Submitted by the expert from the European Commission

Informal document GRB-63-08  
(63<sup>rd</sup> GRB, 16-18 February 2016,  
agenda item 9)

## **Proposal for Amendments of Regulation No. 9**

### Uniform provisions concerning the approval of category L<sub>2</sub>, L<sub>4</sub> and L<sub>5</sub> vehicles with regard to **noisesound emission**

**Table 1**  
**Correction applied to individual measured test value**

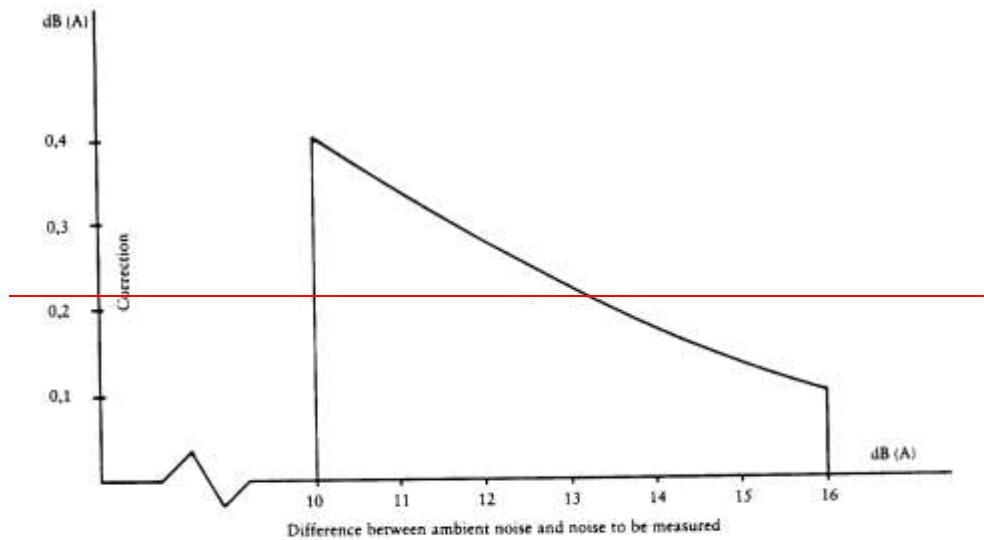
The figure above was deleted because it is in contradiction to table 1.

Figure 2: Microphone positions for the measurement of sound of the stationary vehicle

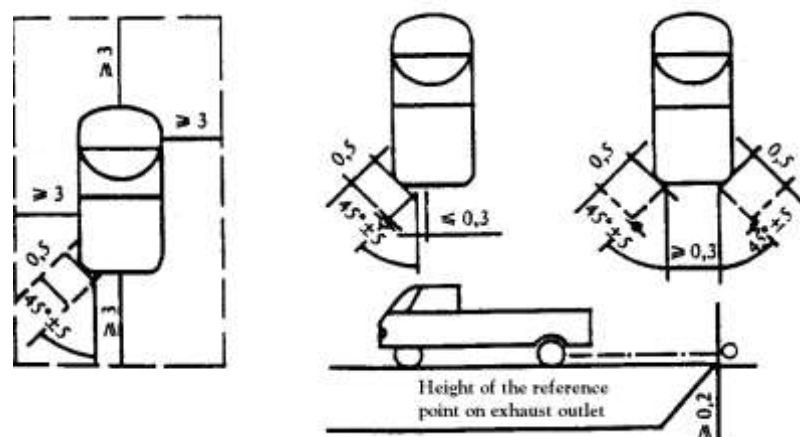
#### 3.2.4.2. Positioning of the microphone (see Figure 2)-of Appendix to this annex)

Figure 4 Test apparatus for conditioning by pulsation

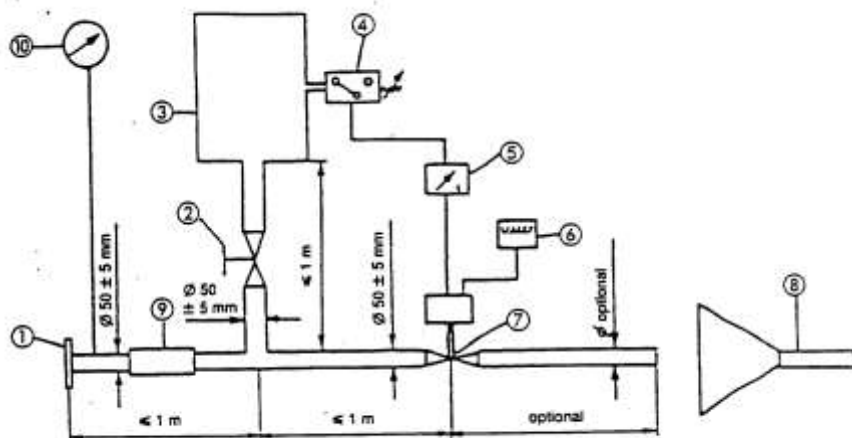
The test apparatus, a detailed diagram of which is shown in Figure 3-4 of Appendix to this annex, shall be fitted at the outlet of the exhaust system. Any other apparatus providing equivalent results shall be acceptable.
